ADDENDUM #1
PROJECT: Firebaugh Center Surveillance Cameras

[Changes to the Project Scope, Scope of Work \(Additions and amendments are highlighted\):](#)

Changes to the Attachments:

Camera RFQ Plans – Addendum 1.pdf

TECHNOLOGY LEVEL 1 OVERALL REFLECTED CEILING PLAN

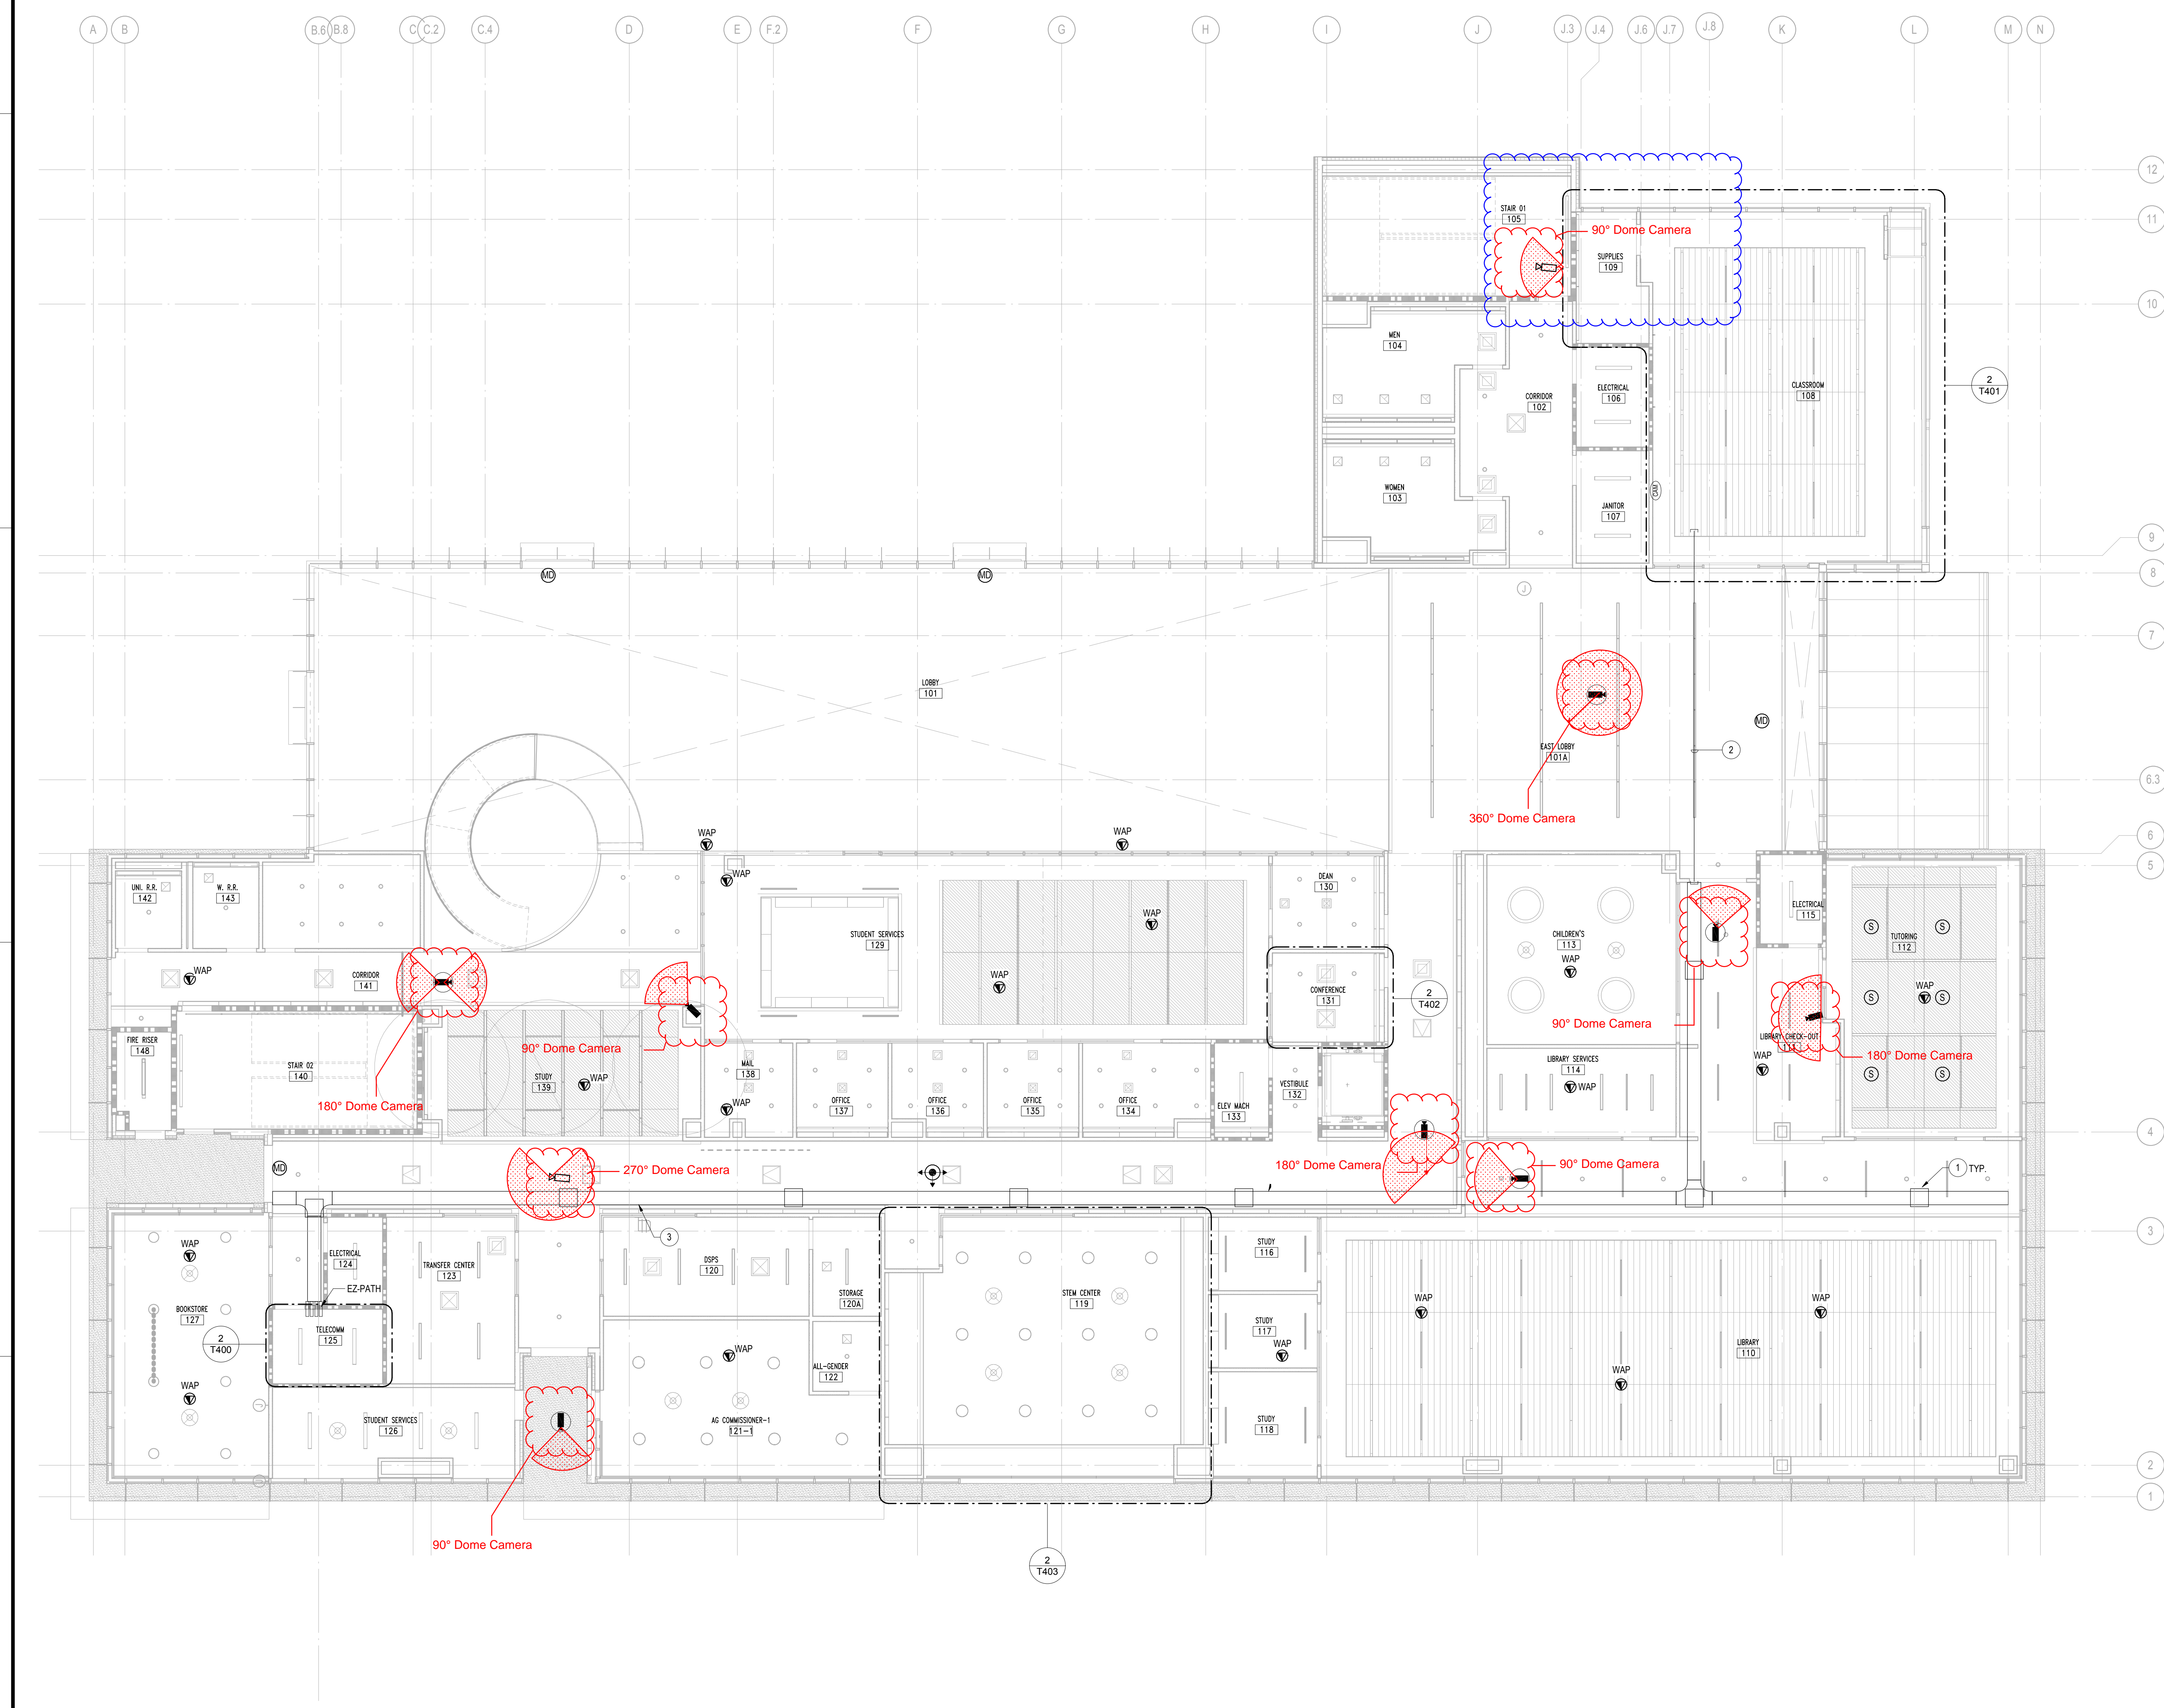
- Stair 205 – 180 degree camera changed to 2x 90 degree cameras.
 - One located on the east wall of Stair 205 on the second floor.
 - The second located in stair 105 east wall on the first floor.
 - This adds an additional network drop.
- Hallway camera facing Telerecom 223 was mis-labeled as 180 degree camera and was corrected to 90 degree labeling.
